**BUSINESS OF THE CITY COUNCIL  
BONDURANT, IOWA  
AGENDA STATEMENT**

**TITLE:** Resolution considering Sankey Summit Phase 2 Preliminary Plat approval

RESOLUTION APPROVING THE SANKEY SUMMIT PHASE 2 PRELIMINARY PLAT

## PRELIMINARY PLAT

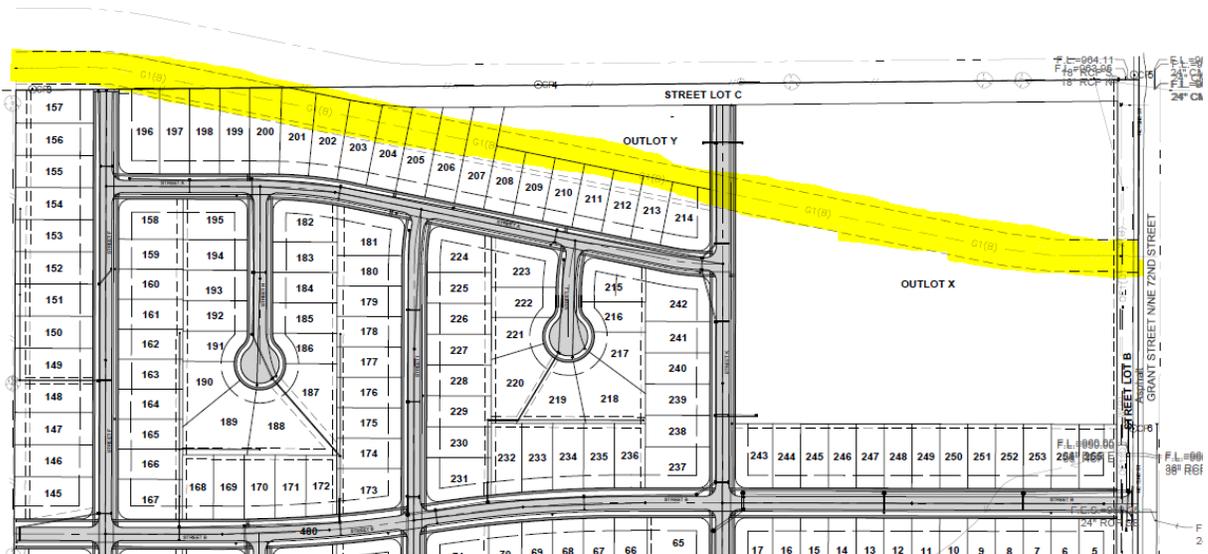
The enclosed preliminary plat shows that the developers are proposing **4.03 acres** of public parkland area in the area shown as Outlot P. Per Section 180.06.8 of the Subdivision Code, another usage that can also be considered acceptable for inclusion as part of minimum public parkland dedication requirements is proposed public trail area not out in the public right-of-way area. The preliminary plat shows a 10'-wide public trail to be constructed by the City that will connect Eagle Park on the development's southwest corner over east to Grant Street North. The City's Park, Trail, and Greenway Master Plan shows a future trail system along Grant Street North continuing to extend further north. The proposed trail segment area plus adjacent greenspace area totals **1.48 acres**.

4.03 acres + 1.48 acres = **5.51 acres**; this exceeds the City's minimum dedication requirement by **0.22 acres**.

Route of 75'-Wide Gas Easement:

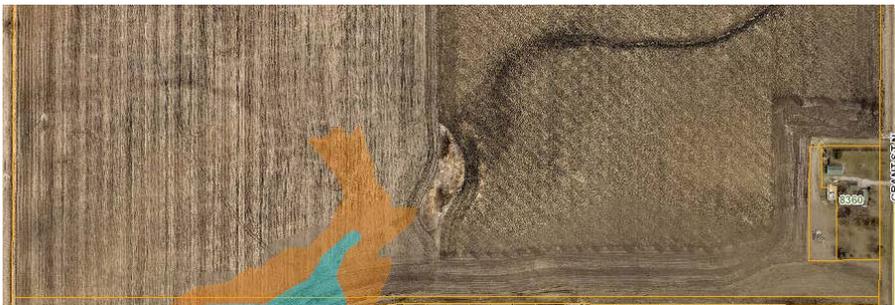
The Comprehensive Plan shows that the existing NE 86<sup>th</sup> Avenue, which currently stops at Grant Street North, should be extended westward in the future. The draft 2020 Streets Master Plan, also shows that NE 86<sup>th</sup> Avenue should be extended westward. The preliminary plat is showing a draft path of NE 86<sup>th</sup> Avenue, but the developer is not proposing actual construction of any portion of NE 86<sup>th</sup> Avenue. On the eastern portion of this proposed development, the draft path of NE 86<sup>th</sup> Avenue is proposed to be situated 50% on this Sankey Summit Phase 2 preliminary plat area and 50% on property to the north owned by Mildred Webb. This draft path then shifts northward as the future street moves west where this potential street route will be located entirely on property owned by Mildred Webb to the north on the western side, as there is an existing 75'-wide natural gas pipeline that shifts to the north just south of in the area shown below. Section 180.05.1.H of the Subdivision Code prohibits establishment of half streets (or in this case, less than half for some area) as part of the platting process. Bob Veenstra noted that potential waiver of this requirement could be considered justifiable due to following: 1.) the City would not want to pull the road further south in this Sankey Summit area without also pulling the existing road further south east of Grant Street North, and 2.) it is highly unlikely that the gas company would allow for construction of such roadway over the gas main.

Section 180.05.1.C of the Subdivision Code, regarding traffic circulation concerns, the Commission included a condition of their approval that the Sankey Summit Phase 2 Preliminary Plat be updated so that Deer Ridge Drive NW no longer connects north up to the NE 86<sup>th</sup> Avenue area and that the Street I area instead be this connection point up to the NE 86<sup>th</sup> Avenue. This updated Street I connection still achieves a connection point from this Sankey Summit Phase 2 Preliminary Plat area up to the NE 86<sup>th</sup> Avenue area; this connection is shown in both the Comprehensive Plan and the draft 2020 Streets Master Plan.

3. That Deer Ridge Drive NW will not connect up to NE 86th Avenue and instead a connection will exist up to NE 86th Avenue in the area of Street I. *Staff's note on this – this item has been addressed as part of a resubmitted preliminary plat.*
